Gearbox fixation on UL-engines type 377, 447, 462, 503 and 532

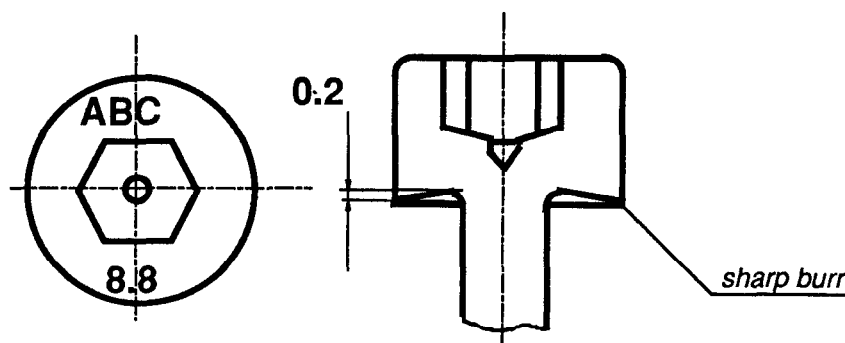
In isolated cases, where heavy propellers were used, screw heads forced into the adapter flange and loosened it.

- a) Screw head contact surface is tapered by 0,2 mm.
Only the outer edge of the screw head is contacting the flange, slackening the screw fit by vibrations.

- Scrap "ABC" screws and order new screws (part no. : see item 1)
- Rework screws showing indents and or burrs, or order new screws.

D: Coat the contact surfaces between adapter flange and crankcase and the screw threads with LOCTITE 221 (ROTAX part no.899 785).

Coat the contact surface of the screw heads with LOCTITE 648 (ROTAX part no. 899 788)

E: Tighten the screws at 50 to 55 Nm.

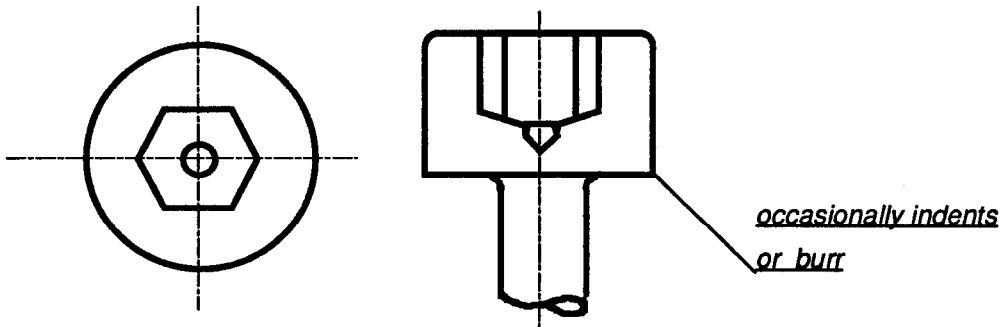
b) If the plane surface has been damaged (knock marks, grooves), screws may slacken.
